Document Ref: 8.46 PINS Ref: EN010082

Tees CCPP Project

The Tees Combined Cycle Power Plant Project

Applicant's Response to Examining Authority's Second Written Questions

Figure 1: De-seasonalised trends in SO₂ concentration, 1992 to 2016 at 7 long running Automatic Urban and Rural Ambient Air Quality Monitoring sites

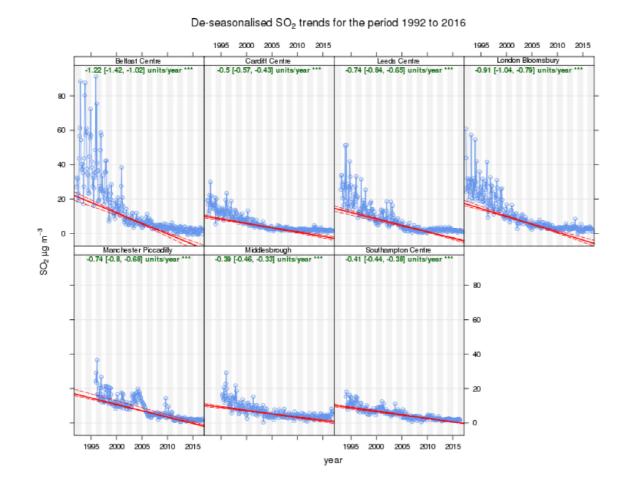
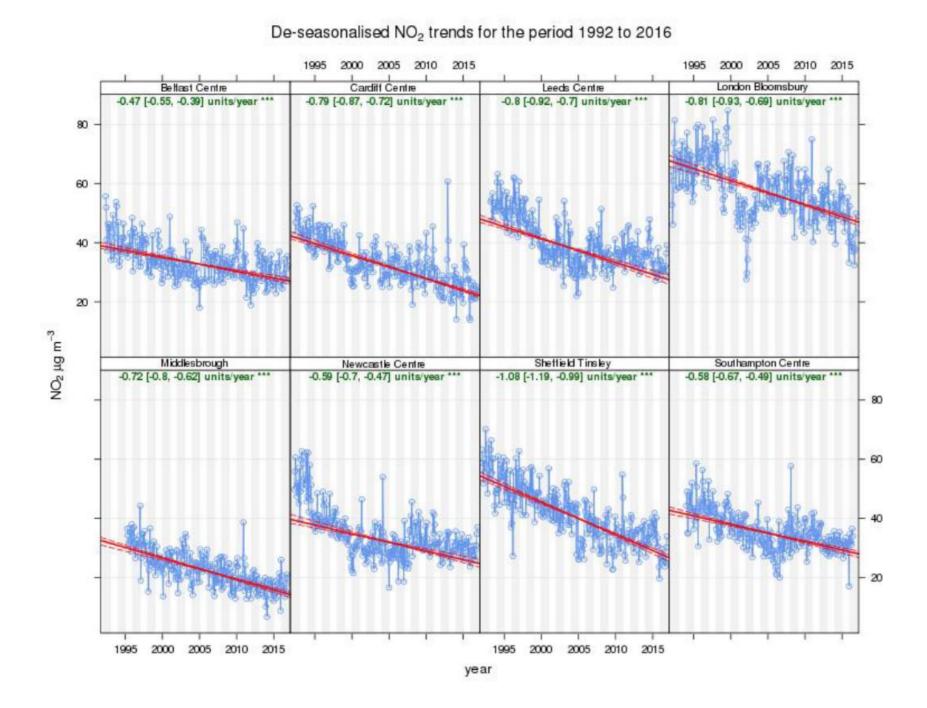
| REF NO. | RESPONDENT | QUESTION | LEAD | RESPONSE |
|---------|------------------------------|---|------------|--|
| Q2.0.3 | Applicant Natural England | The Applicant maintains a position that it is not feasible to undertake a quantitative assessment of in-combination air quality impacts [REP4-011]. The finding of no likely significant effects with regards to the assessment of in- combination effects lacks authoritative evidence in the form of quantitative data. In absence of such evidence it is not obvious how the Applicant has arrived at the outcome of no likely significant effect. The Wealden judgement clearly demonstrates the importance of addressing this issue as a matter of legal principle. It is also important to note that the in-combination assessment suggests that there is a 'widespread reduction in emissions' in the surrounding area. The robustness of this assertion would be increased if the evidence to support it was provided. In order to address the points raised above can the Applicant and NE explain what information is available to support the Applicant's position of ongoing improvements to background emission levels? The Applicant should also explain how, in absence of a quantitative in-combination assessment, the findings of no likely significant effect | ERM | The Project, in itself, does not result in significant impacts, with all impacts being below 1% of Long Term Critical Loads and Critical Levels. In combination effects are also anticipated to be insignificant, given that there is only one additional industrial facility that may be operational, that being the Tees Renewable Energy Plant. The EIA for the Tees Renewable Energy Plant has also concluded that in itself there would not be significant effects. The two plants are not co-located, and therefore any impacts are anticipated to arise on different locations and habitats. Furthermore, we believe that the process of completing a quantitative in combination effects assessment without the data from an EPC could result in an overly conservative assessment. Once an EPC has been appointed a quantitative assessment would be completed as part of the environmental permitting process. If significant effects are determined the next step would be to undertake further refinement of the dispersion modelling results. At the present time, the most sensitive habitat within each ecological receptor is assumed to coincide with the highest impact. In practice this is unlikely to be the case, as some sites are large. Following this, if significant impacts remain, then initial steps in the Appropriate Assessment process would be initiated. This, initially, comprises consideration of the site condition and species present and verifying whether the potential for an impact to arise in practice is actually possible. Further steps to assess the actual potential for harm to arise would follow. Furthermore, the overall air pollution and deposition at the habitat sites would continue to reduce in line with national trends. A key consideration in the Applicant's assessment is that in UK air quality has generally been improving in the long term, with substantial improvements since the 1960's-1980's in sulphur dioxide, oxides of nitrogen and transboundary pollution. This is clearly evidenced in the DEFRA document re |

As discussed in the response to Question 2.0.3, emissions to air have reduced markedly and air quality substantially improved as a result. These reductions began to be realised in the 1950's and 1960's with the introduction of the Clean Air Acts. The trend towards reduced emissions continued in the 1980's and 1990's with ever more stringent emission limits on industry and the adoption of emission limits on road vehicles. From the 1990's to the present day, there has been continued, marked reductions in emissions as ever more stringent emission limits are brought in through the Industrial Emissions Directive, industrial technology is continually improved, road vehicle emissions decrease and coal is phased out of power generation and domestic homes. This is a trend that will continue into the future, with ever lower industrial emissions being driven by the adoption of BAT Reference Notes (Bref Notes) and ever more stringent vehicle emissions limits, and uptake of non-fossil fuelled vehicles.

In both cases, the decrease over the period of 1992-2016 is clear and is apparent at all the sites, irrespective of the absolute concentrations. Of particular interest are the results from Middlesborough, noting that this site is close to the Sembcorp facility. The reduction in airborne pollution are directly correlated to emissions, as illustrated in the following figures.
